# Access Compliance Report

## Public Rights-of-Way

### (Curb Ramps)

Intersection ID: 5858	Main Street: CARMENET_LN	Cross Street: LONG_PAW_LN	Location: NW
ADA ID: CB4733D950C3	Ramp Type: PerpDiag	Initial Pass/Fail: Fail	Overall Compliance: No
		Severity Score: 22.5

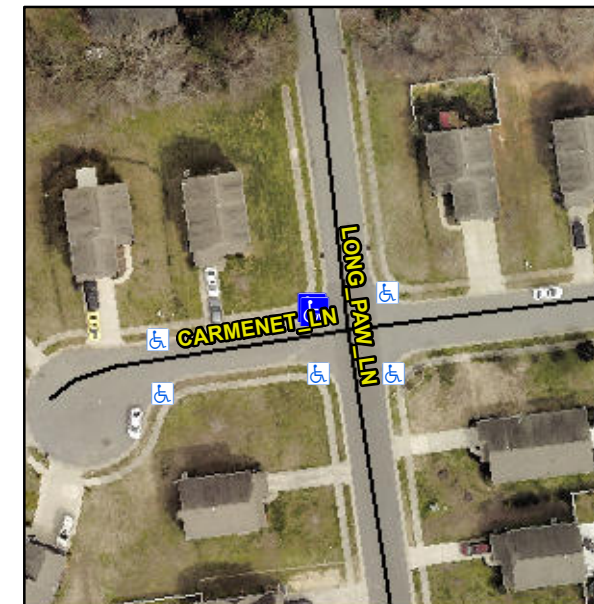
**Not Found, R304.5.1, R304.2.2, R304.5.3**

Compliance	Description	Data	Compliance	Description	Data
N/A	Ramp Length (in)	48.0	No	Ramp Slope (%)	11.3
No	Ramp Width (in)	41.0	No	Ramp XSlope (%)	3.0
N/A	Flare Type LT	N/A	N/A	Flare Type RT	N/A
N/A	Flare Slope LT (%)	N/A	N/A	Flare Slope RT (%)	N/A
N/A	Flare Traversable LT?	N/A	N/A	Flare Traversable RT?	N/A
N/A	Landing Length (in)	N/A	N/A	DWS Provided?	N/A
N/A	Landing Width (in)	N/A	N/A	DWS Contrast?	N/A
N/A	Landing Slope (%)	N/A	N/A	DWS Length (in)	N/A
N/A	Landing X Slope (%)	N/A	N/A	DWS Full Width?	N/A
N/A	Landing Curb? (Y/N)	N/A	N/A	DWS Offset (in)	N/A
N/A	Shared Landing?	N/A			
N/A	Gutter Ponding?	N/A	N/A	Gutter Slope (%)	N/A
N/A	Gutter Lip Ht (in)	N/A	N/A	Gutter X Slope (%)	N/A
N/A	Painted X Walk1?	No	N/A	Painted X Walk2?	No
	X Walk 1 Direction	To S		X Walk 2 Direction	To E
N/A	X Walk 1 Width (in)	N/A	N/A	X Walk 2 Width (in)	N/A
	X Walk 1 Slope (%)	0.6		X Walk 2 Slope (%)	4.6
	X Walk 1 X Slope (%)	1.2		X Walk 2 X Slope (%)	3.4

**Remove & Replace Curb Ramp With Two New Directional Ramps or Equivalent.**
